***IN THE MATTER OF***  
***COMPLAINT AGAINST THE EL SEGUNDO***  
***ENERGY CENTER PROJECT***

**Docket No. 12-CAI-03**  
**Docket No. 00-AFC-14C**

**[PROPOSED] COMMISSION ORDER ADOPTING THE SETTLEMENT  
AGREEMENT AMONG THE PARTIES TO THE COMPLAINT AGAINST  
THE EL SEGUNDO ENERGY CENTER**

### Joint Statement of Agreement

PROPOSED SOUTH SLOPE:  
 **301 VISTA DEL MAR BOULEVARD**  
**EL SEGUNDO ENERGY CENTER**  
 CITY OF EL SEGUNDO COUNTY OF LOS ANGELES STATE OF CALIFORNIA

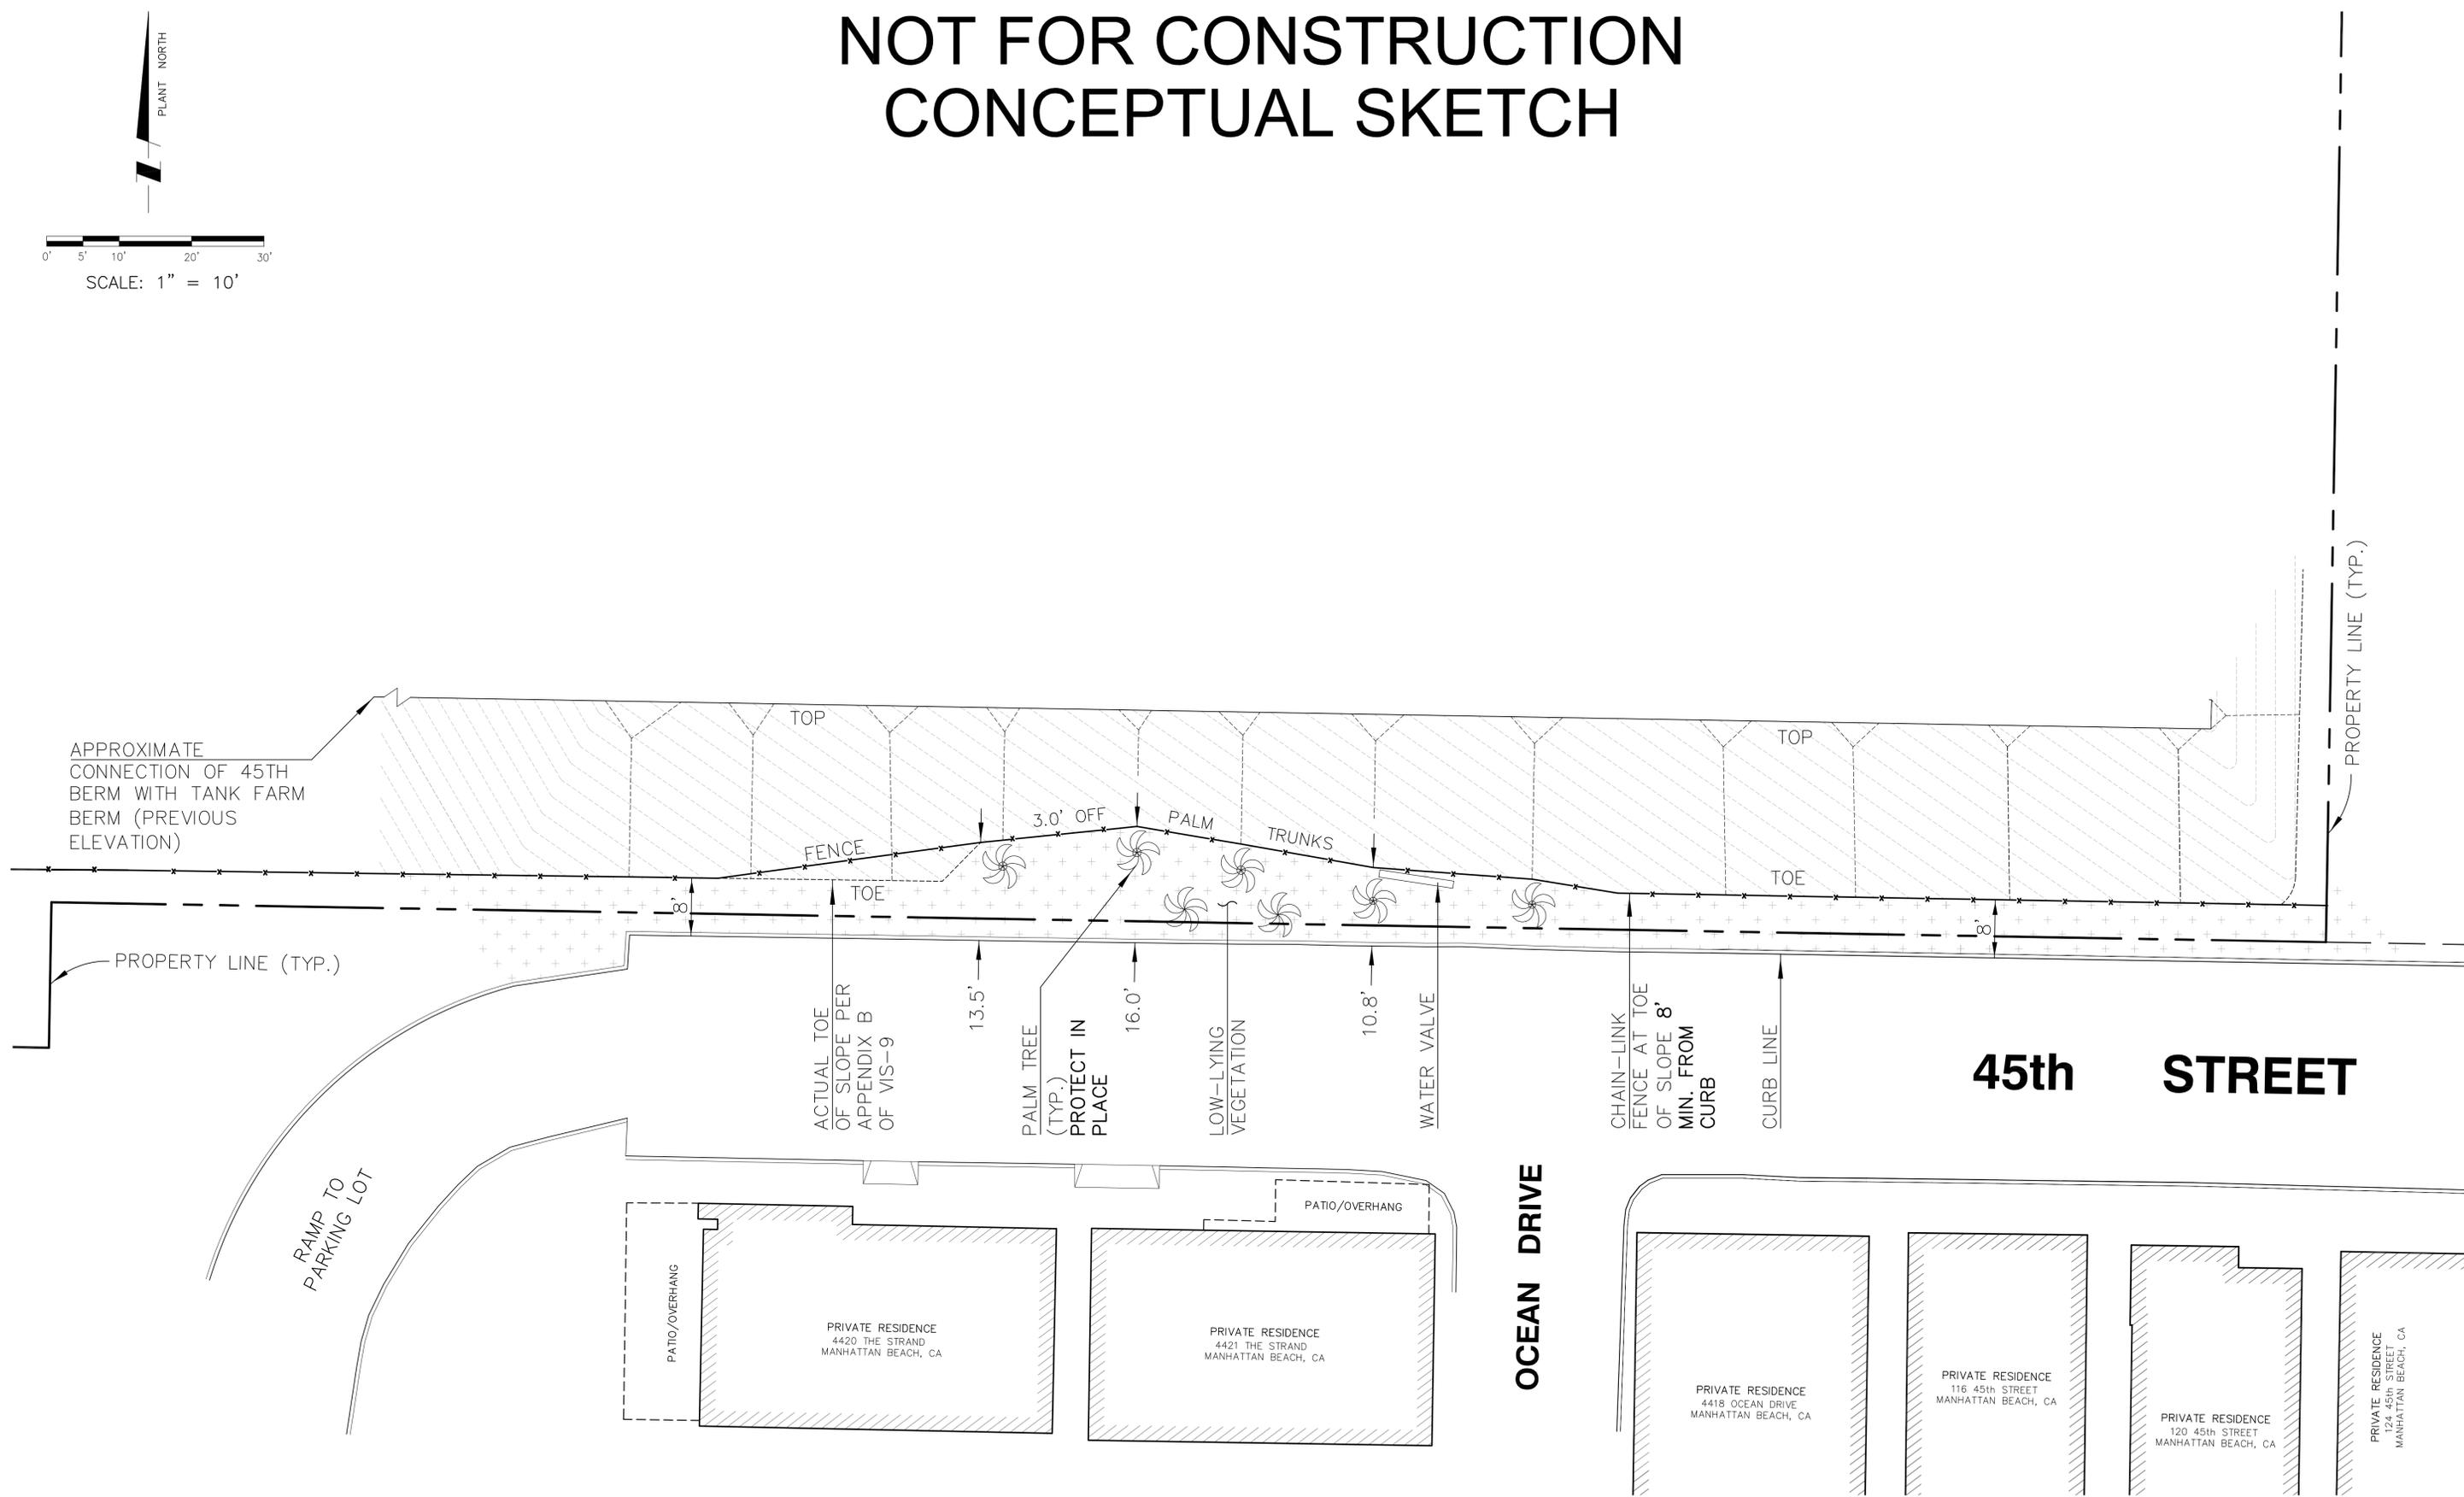
- a. The Parties jointly agree that the steepness of slope of the new 45th Street berm shall be increased in the area of the existing potable water valve and existing palm trees so the toe of the slope do not reach the trees and that the existing palm trees shall be retained and incorporated into the landscaping. A general depiction of intended location of the toe of the slope is provided in Attachment A to this document.

similar to historic fence location. The Parties recognize that the exact location of the fence was never strictly decided in the past and that documents differed on its location. The Parties also acknowledge that a temporary fence on the southern property line is necessary during construction of the southern area landscaping features but that it will be replaced with the permanent fence promptly upon completion of the landscaping along the southern perimeter. A general depiction of the intended location of the fence is provided in Attachment A to this document.

- 5) ESECL agrees to prepare and submit to the City of Manhattan Beach, the City of El Segundo and the Parties for comment and then to the Compliance Project Manager (CPM) for approval, a revised 45th Street Berm Drawing (Appendix B to the *Temporary Landscaping and 45th St. Berm – Vis-9* landscaping plan) that reflects the increased slope steepness to pull the slope back from the existing palm trees. The drawing should be consistent with the sketch provided as Attachment A.

- 6) ESECL agrees to prepare and submit to the City of Manhattan Beach, the City of El Segundo and the Parties for comment and then to the CPM for approval a revised sheet number 4 to Appendix A of the ***Temporary Landscaping and 45th St. Berm – Vis-9*** landscaping plan showing the revised berm slope and exact final location of the permanent fence along the southern property line. The drawing should be consistent with the sketch provided as Attachment A.
